**Application for Permission under Section 16 of the Town Planning Ordinance (Cap.131)**  
**Temporary Shop and Services (Motor-vehicle Showroom) with Ancillary Parking of Vehicles for a Period of 5**  
**Years**  
**in “Comprehensive Development Area” Zone at Various Lots in D.D. 104 and Adjoining Government Land, Long**  
**Ha, Yuen Long**  
**(Planning Application No. A/YL-KTN/1255)**

**Submission of Further Information (1)**

**Attachment 1 - Response-to-Comments Table**

| DRAWING TITLE<br><br>FIRE SERVICES INSTALLATION LAYOUT PLAN                                                                                                    |                |               |            |       |

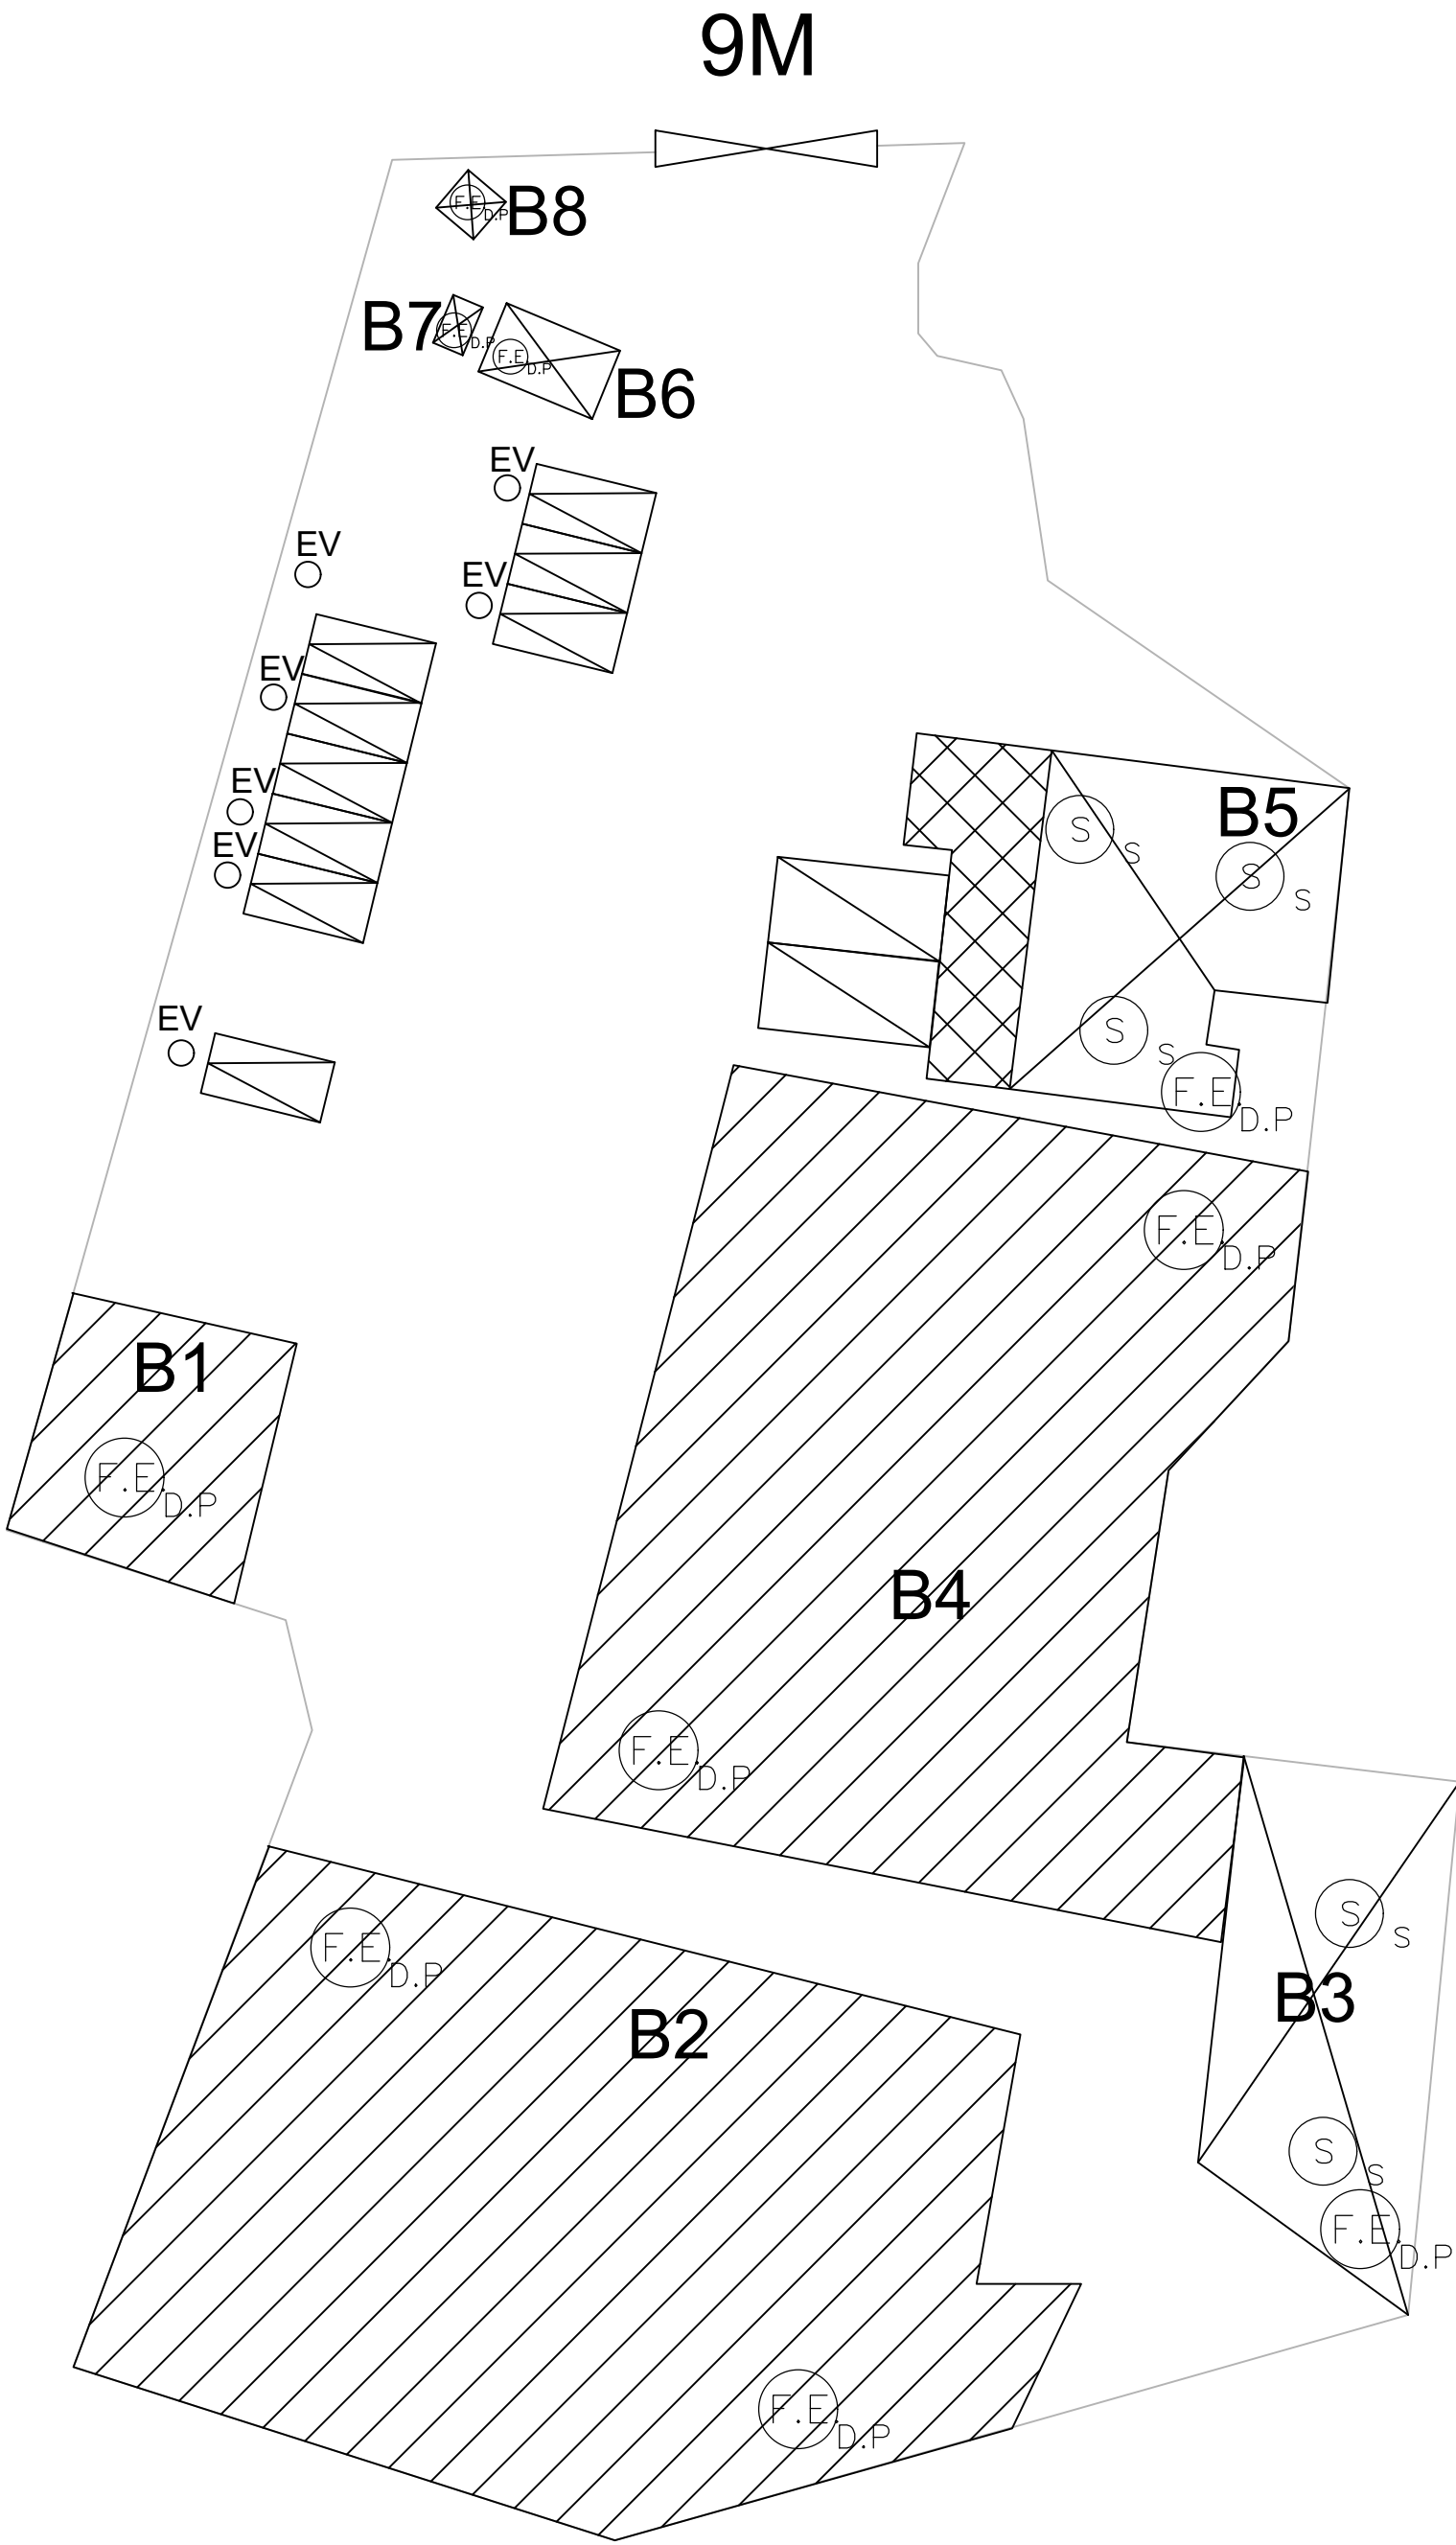
| No. | Comments                                                                                                                                                                                                                                                                                                      | Responses                                                                                                                                     |
|-----|---------------------------------------------------------------------------------------------------------------------------------------------------------------------------------------------------------------------------------------------------------------------------------------------------------------|-----------------------------------------------------------------------------------------------------------------------------------------------|
| 2   | <p><b>Fire Services Department (Contact Person: Mr. YUEN Tsz-fung), dated 21.7.2026</b></p> <p>i. For enclosed structure with gross floor area not exceeding 230 m<sup>2</sup>, portable fire extinguisher and stand-alone fire detector shall be provided;</p>                                               | <p>Please refer to the FSIs proposal with the latest layout of the captioned application on <b>Attachment 2</b>.</p>                          |

LAYOUT PLAN

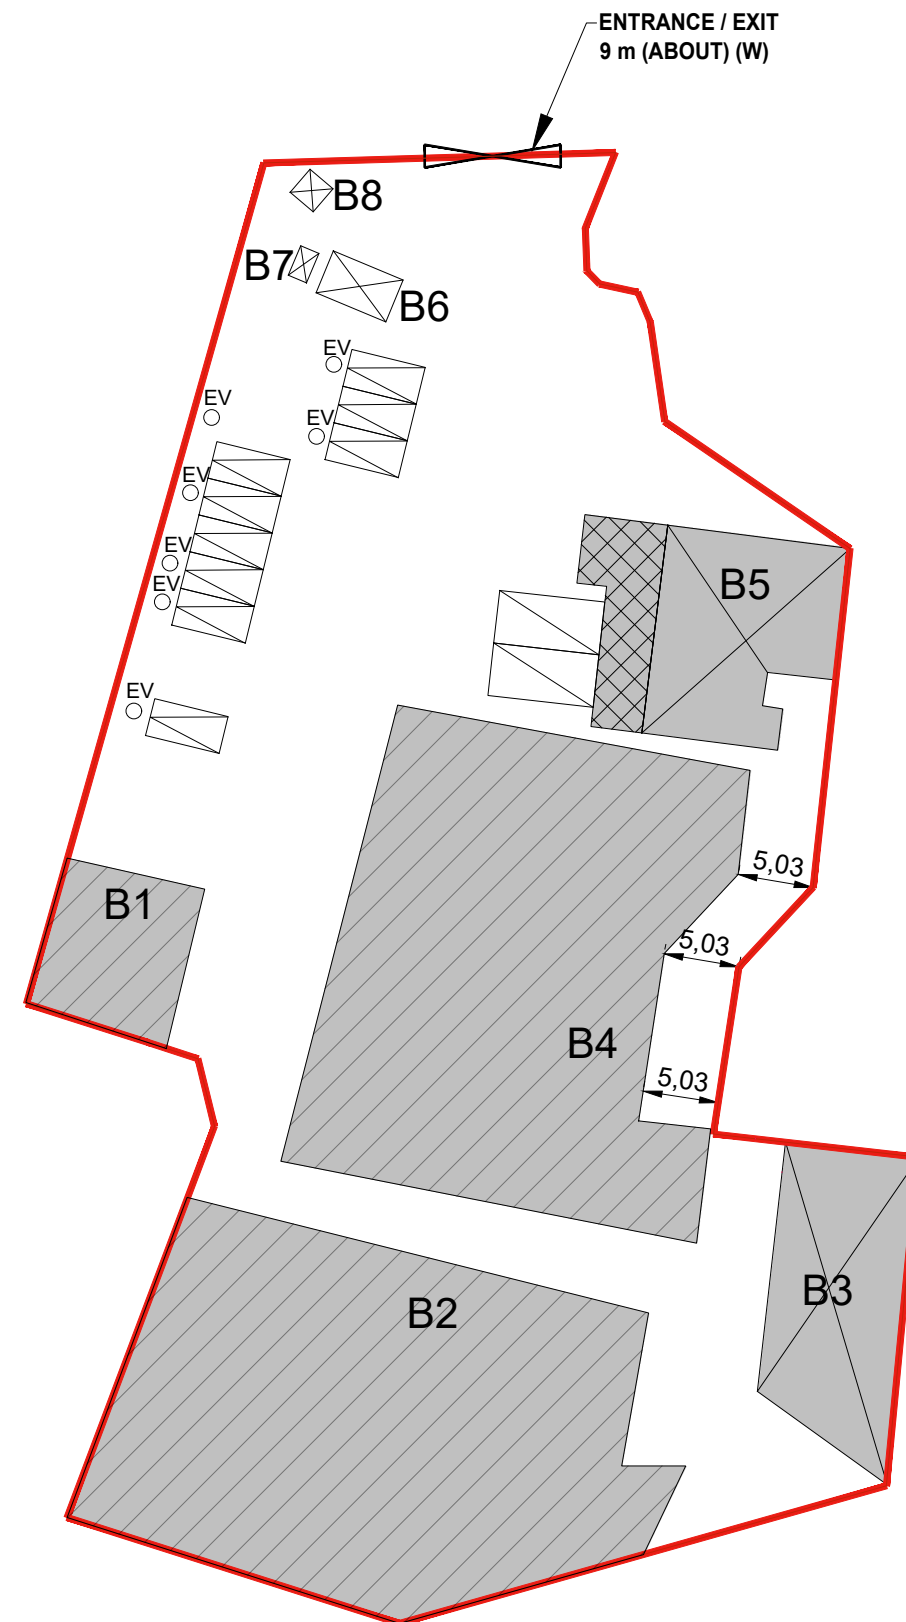
| <b>3</b> | <p><b>Fanling, Sheung Shui, Yuen Long East District Planning Office (Contact Person: Ms. Andrea YAN), dated 27.7.2026</b></p> <p>(a) According to the site photos, there are existing trees along the eastern and western boundaries of the site. Please clarify whether the trees within the Site will be retained and whether any of the proposed structures (in particular structures B3 and B4) are in conflict with the trees.</p> | <p>The Site has already been hard-paved and it is observed that there are existing trees along the site boundary. The development would retain all trees within the Site. As shown on the revised <b>Plan 1</b> and <b>Plan 4</b>, the disposition of the proposed structure B4 has been slightly adjusted (5m setback from the site boundary) so as to preserve and provide adequate growing spaces for the existing trees along the eastern boundary of the Site. In addition, structure B3 is an existing structure by which there would be no revision on the form and disposition.</p> |
